**TOWN OF WELLINGTON
PLANNING COMMISSION**

**May 3, 2021
6:30 PM**

Date: May 3, 2021
Submitted By: Cody Bird, Planning Director
Subject: Site Plan Review - 3700 Cleveland Ave.

Date: May 3, 2021
Submitted By: Cody Bird, Planning Director
Subject: Site Plan Review - Lot 1, Block 6, Wellington (3749 Harrison Ave.)

SITE PLAN

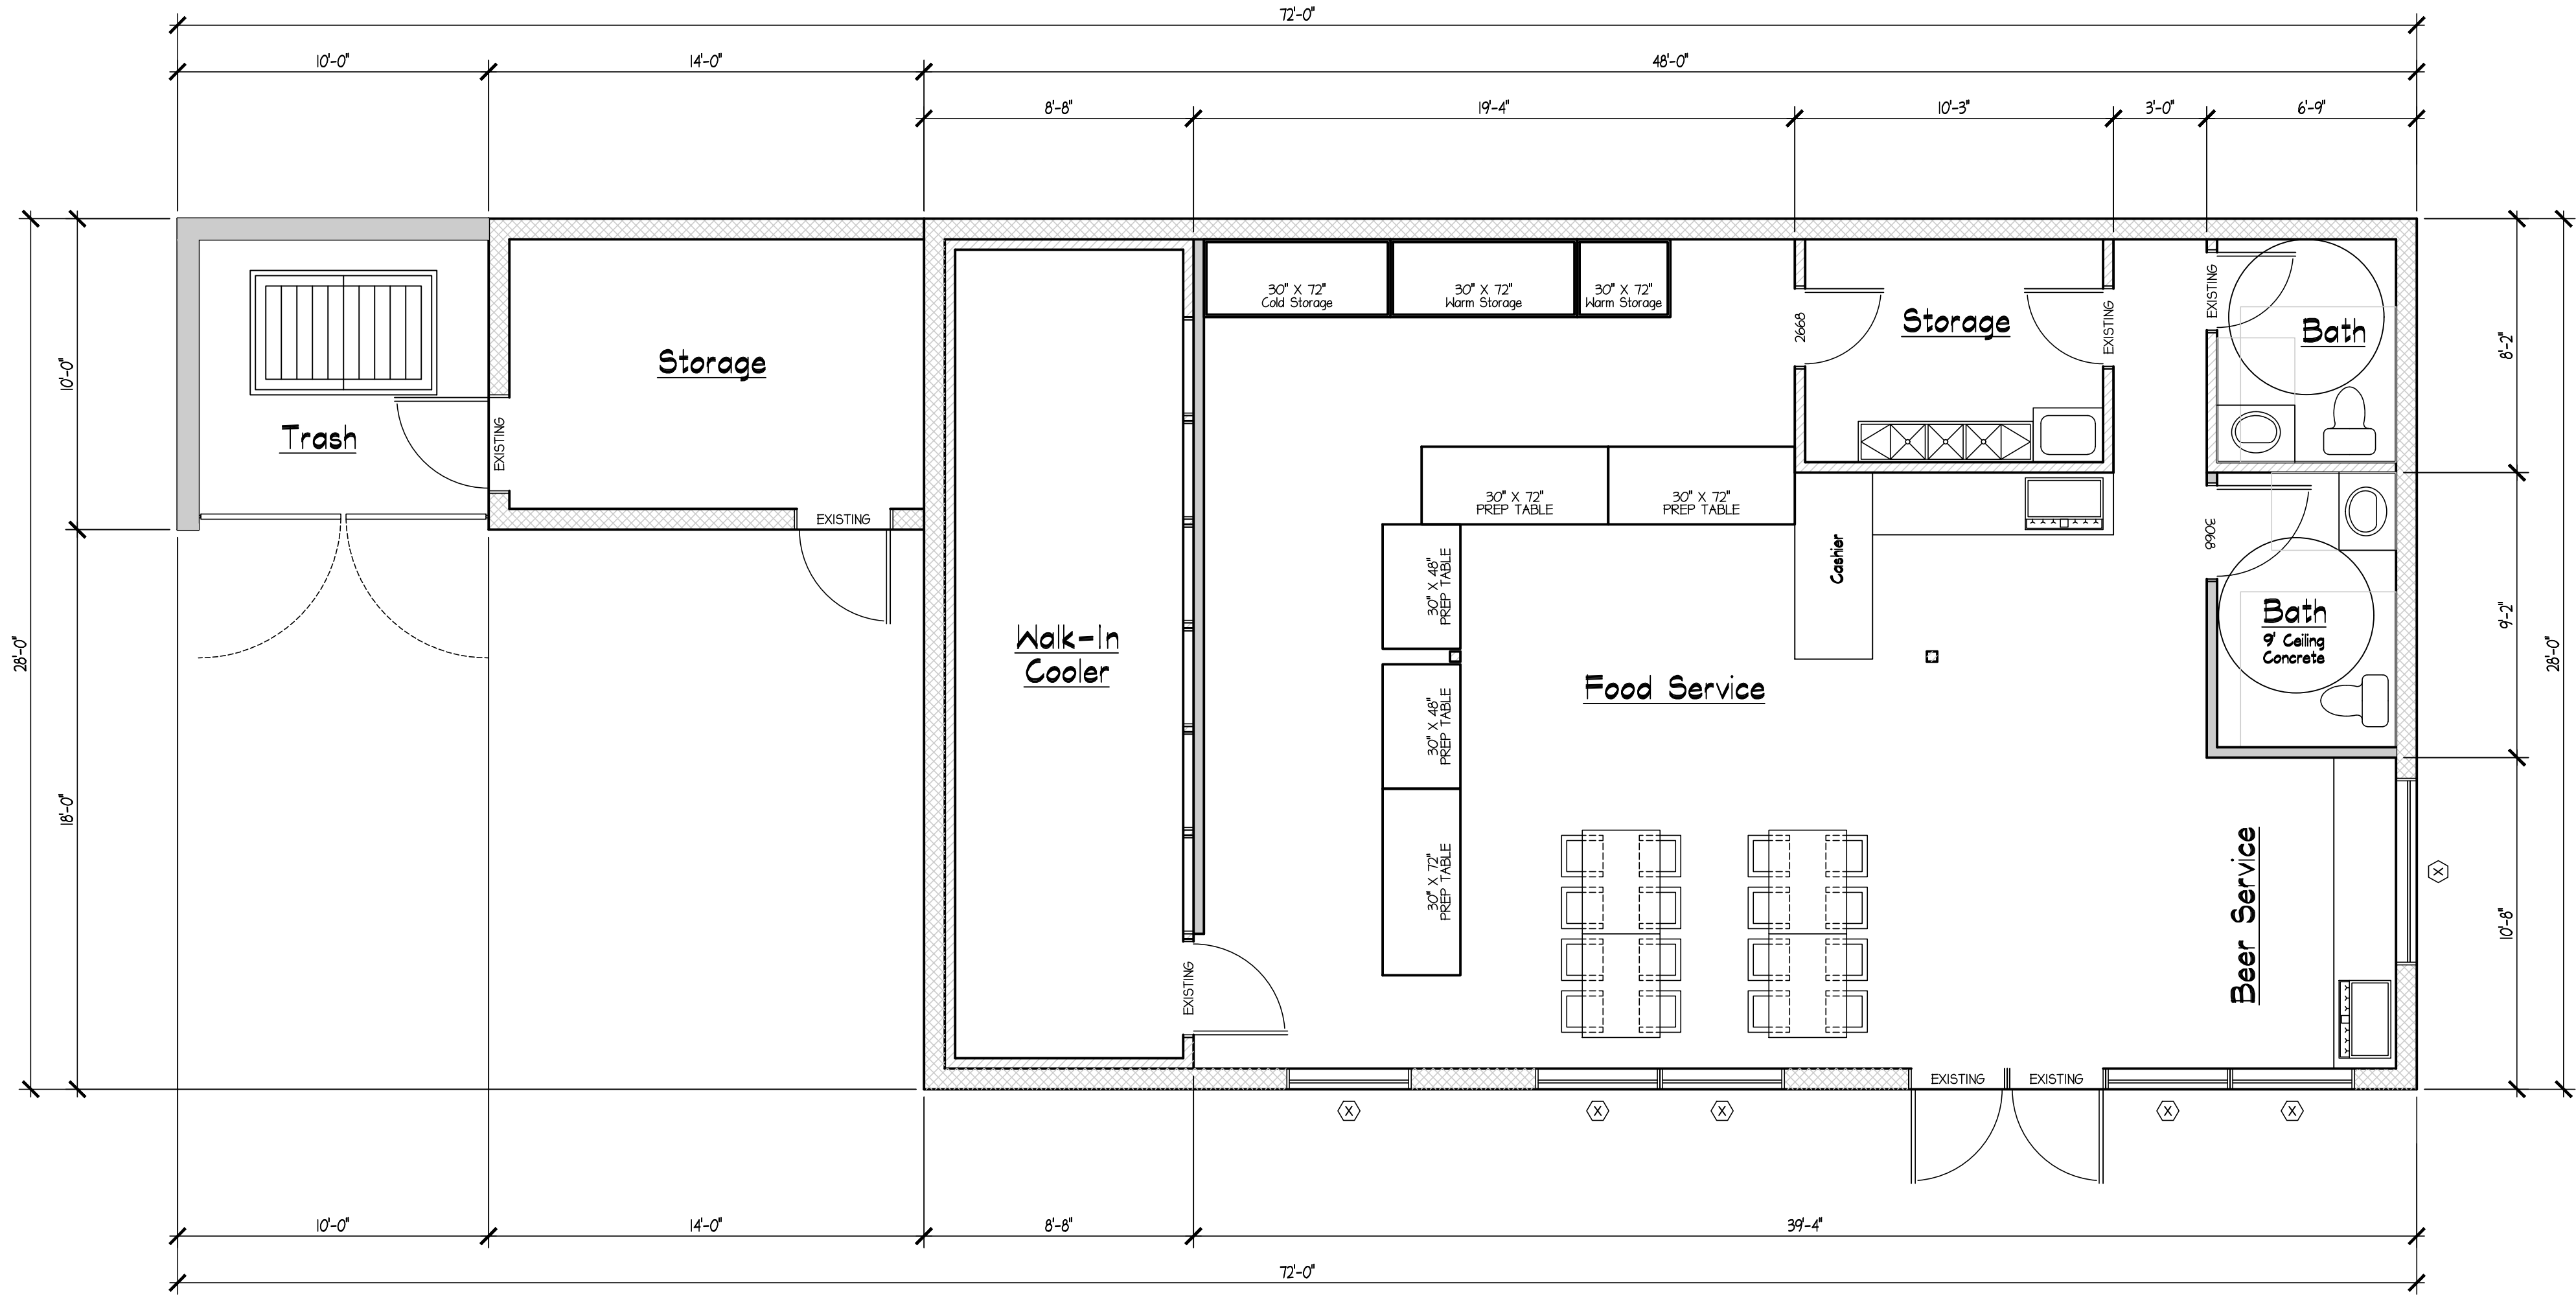
3. Streets and Access: The site is on the corner of Cleveland Ave. and First St. There are existing driveways to both Cleveland Ave. and First St. The applicant, at Town staff's request, is proposing to restrict access to/from Cleveland Ave. The proximity of the driveway to the intersection is not desirable and not needed for the proposed use of the site. Planter boxes are proposed as a means of created a physical and visual barrier to vehicle access at the Cleveland Ave. driveway. The First Street driveway is allowed to remain for use by the mobile food vendors. It is anticipated that the vendors would park in the driveway to limit vehicle access during times the

4. Pedestrian Connection: There are existing sidewalks along Cleveland Ave. and First Street connecting the site to other public sidewalks. The site plan appears to show a portion of the outdoor dining or patio area on the existing sidewalk along Cleveland Ave. Additional details on the site plan may need to be coordinated with Town staff to better understand if sidewalk seating is desired or proposed. The proposed planter boxes are identified as being located within the Cleveland Ave. sidewalk area. This proposal may be acceptable, or the planters could also be utilized as an element creating the perimeter required for the proposed liquor license area. Staff recommends that final details of the sidewalk use and planter locations be handled administratively with Town staff to ensure all pedestrian and accessibility needs are satisfied. Egress paths through the liquor license area will also need to be evaluated with the Fire District.

5. Parking: The applicant is proposing to provide up to 4 off-street parking spaces on the site accessed from the alley. Within the C2 district, the off-street parking requirement is to provide the rear 25 feet of the property for parking spaces. This requirement is generally satisfied for the proposed site plan, exclusive of areas encumbered by structures and the proposed trash enclosure. Dimensions for the parking spaces are not identified, so the applicant should verify if the minimum 10 ft. x 20 ft. dimensions are satisfied. Wheel stops are proposed and should be a requirement to create some physical separate from the outdoor activity areas. If possible, the parking spaces could be shifted to the east to provide a little separation between the sidewalk along First Street and opening car doors.

- The ADA van accessible space must be a minimum of 132 inches (11 feet) wide with a minimum adjacent 60-inch (5 feet) wide access aisle. The applicant should verify the minimum widths for ADA are satisfied. The van accessible parking space is required to have a sign with "van accessible" placard posted in front of the space. The bottom of the placard must be a minimum of 60 inches above adjacent grade.

- The ADA accessible aisle should be arranged to be on the passenger side of the van parking space.
- Spot elevations for grading are not currently available. The applicant or their agent should evaluate existing grades to ensure all ADA slope requirements are satisfied. At a minimum, there appears to be a need to identify some changes at the building entrance to accommodate a ramp and possibly the door threshold to meet the ADA accessibility requirements. This can be further coordinated with Town staff at the time of a building permit for the building modifications.

- There are no new signs currently identified on the site plans. The applicant is encouraged to consider what type of signage may be desired. A separate sign permit can be obtained from Town staff.
- The existing sign frame from the former convenience store is a nonconforming structure due to its size and location which obstructs visibility at the intersection. The zoning code provides that a nonconforming sign shall be removed upon a change in use of the property. The change of use from a convenience store to a restaurant necessitates removal of the abandoned sign frame.

10. Landscape/Screening and Buffering: The existing site is completely hardscaped with concrete or asphalt. As an alternative to help provide some greenery on the site, the applicant is proposing planter boxes. The planter boxes will help provide some visual aesthetic to soften the site. Consideration of placement of the planter boxes will also help to achieve some screening of the outdoor patio area without completely obscuring views into and out of the site. Size of the boxes, design and water supply should all be considered when designing and installing the boxes.

SITE PLAN

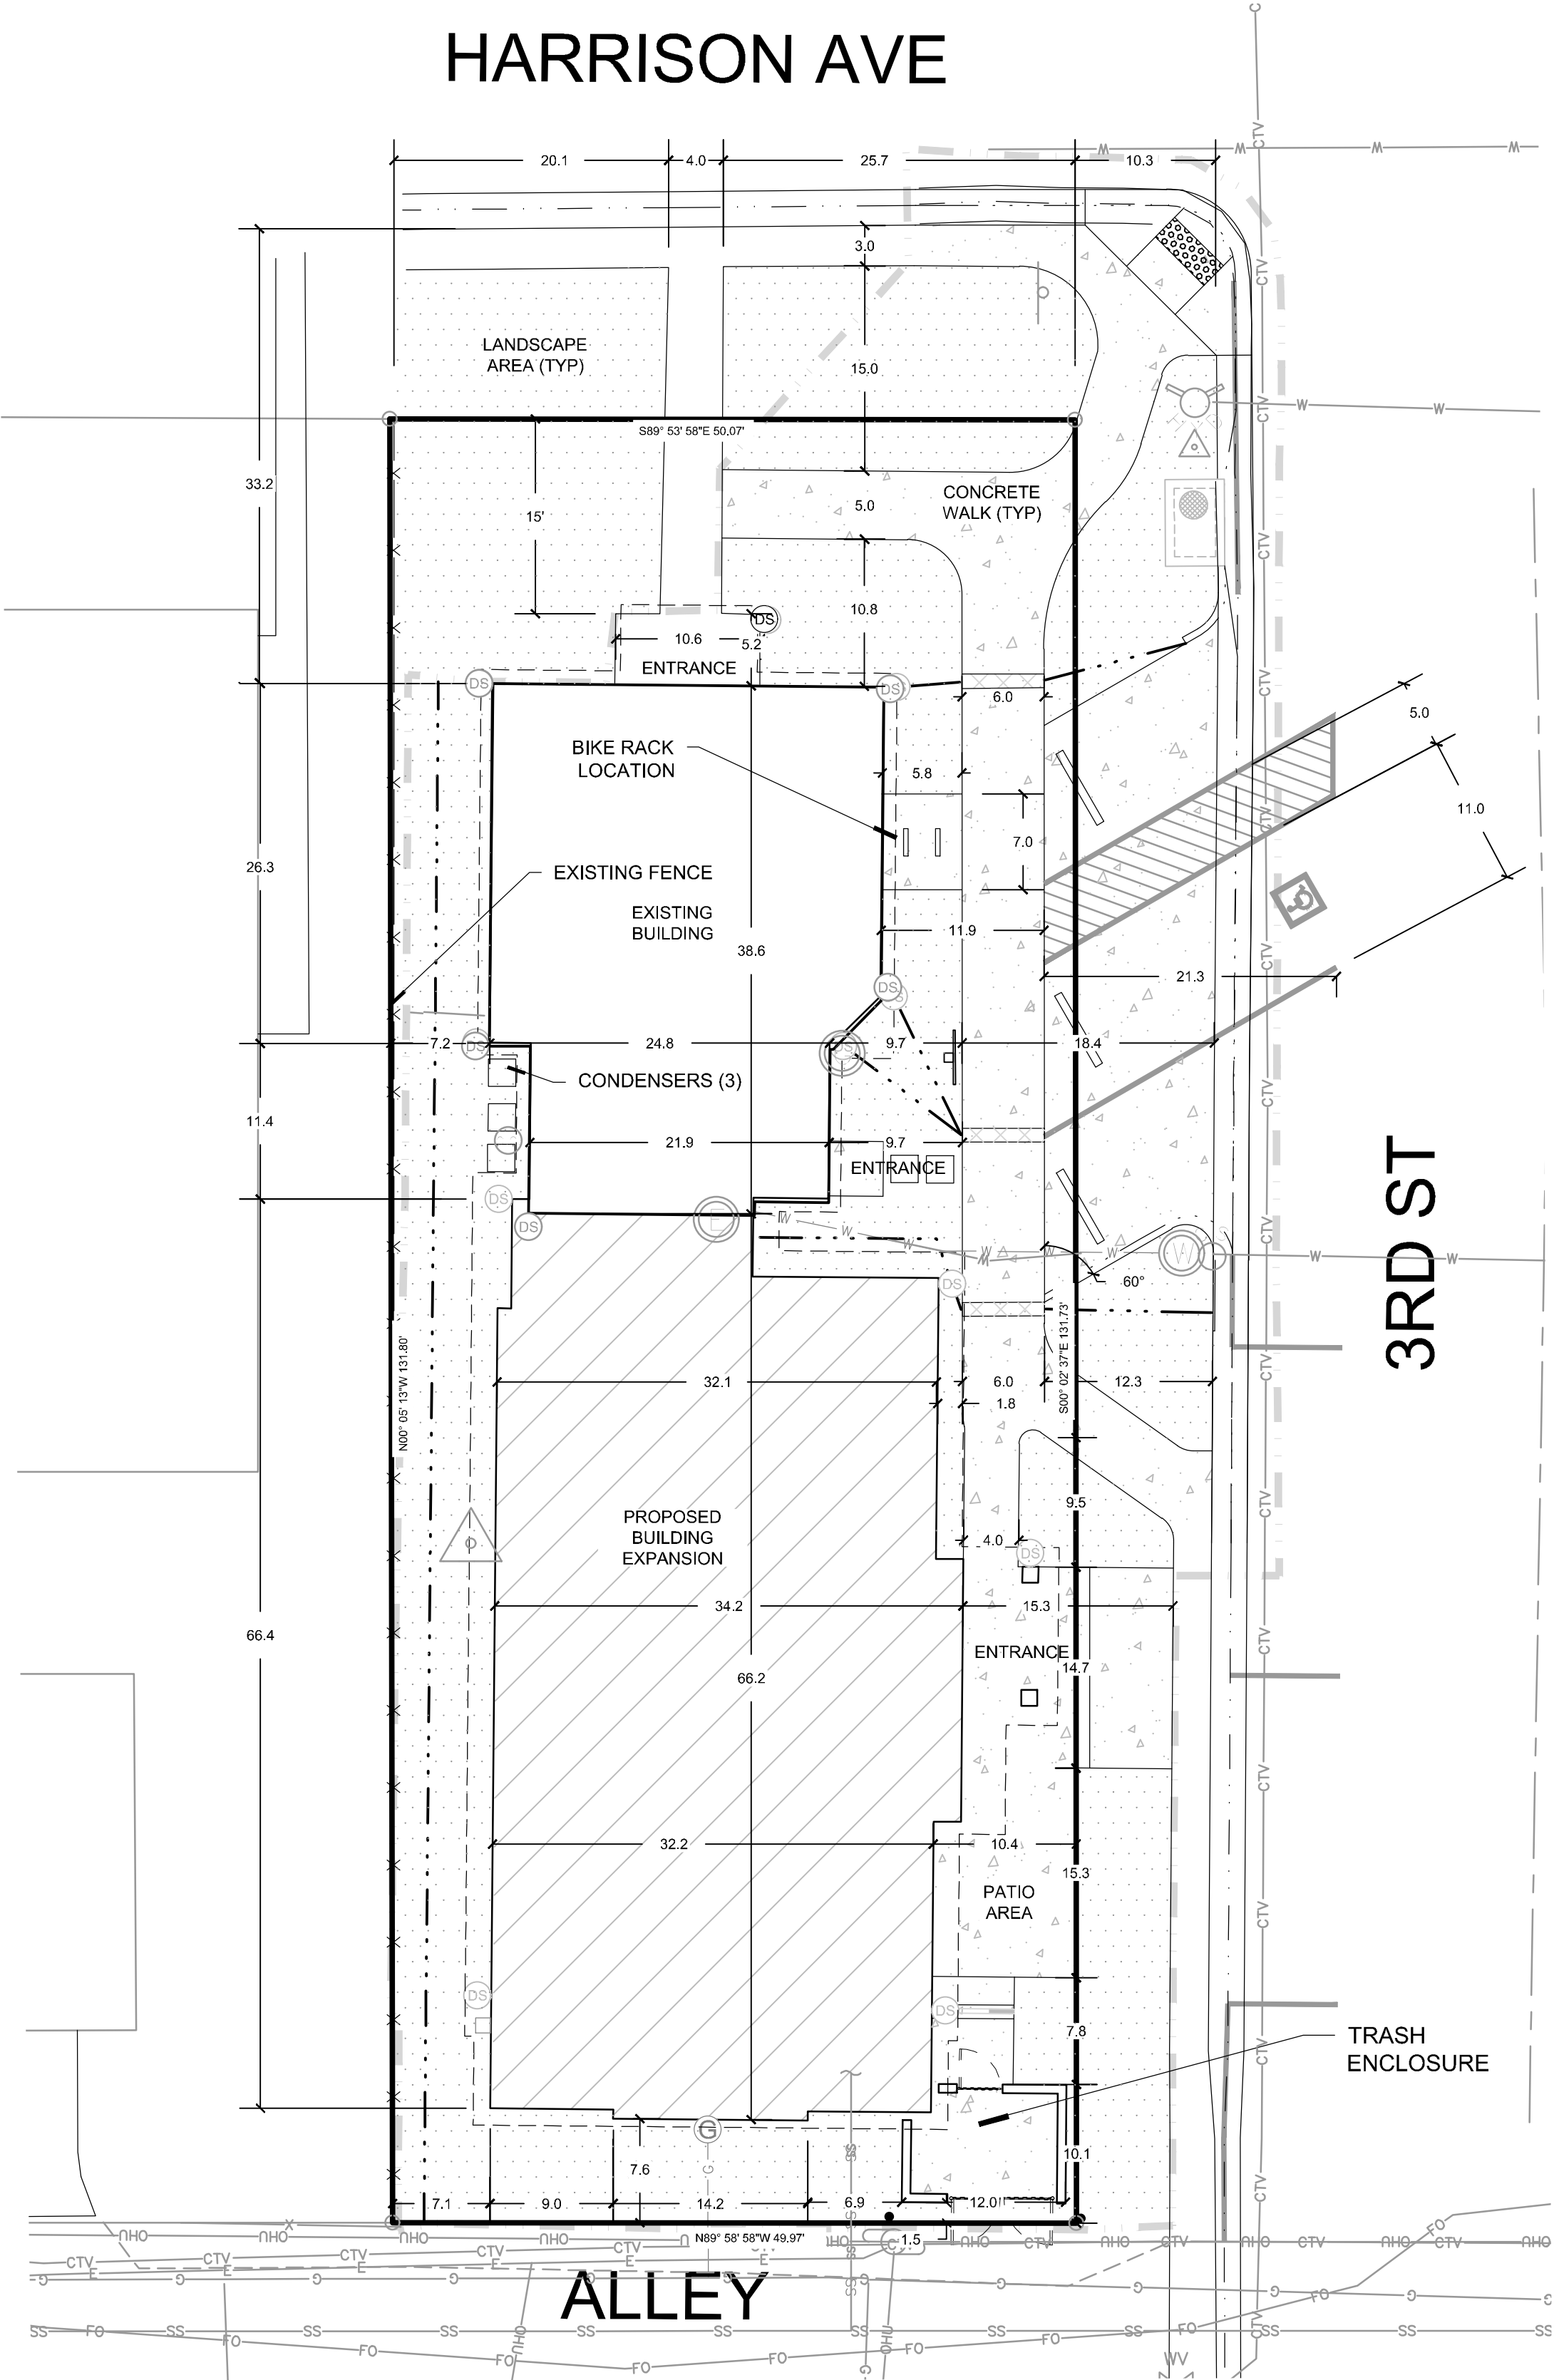
3. Streets and Access: The site is on the corner of Third Street and Harrison Avenue, one block north of Cleveland Avenue. There is an existing driveway to a detached garage accessed from Third Street. The existing detached garage and driveway are proposed to be removed as part of the project. No driveways are proposed for the new site plan. The only vehicular access proposed are 3 diagonal parking spaces on Third Street that are proposed to meet the ADA accessible parking needs for the site.

- Portions of the existing sidewalks are less than the minimum width to meet Town standards. All sidewalks should meet current Town standards for width and should be updated on the revised site plans.
- The sidewalk crossing of the alley adjacent to the site should also be evaluated and considered for replacement if width and ADA accessibility are not satisfied.

5. Parking: Office uses are required to provide a minimum of 1 parking space per each 300 sq. ft. of gross floor area. The proposed building is proposed to have 4,778 sq. ft. of office floor area, so 16 parking spaces are required.

- Wheel stops for the diagonal parking are proposed to ensure parked vehicles do not obstruct the sidewalk. There is 18 ft. shown from the wheel stop to the back of the parking space. The applicant should verify that there is sufficient space to accommodate a 20 ft. long vehicle to meet the Town's parking stall dimension requirements.
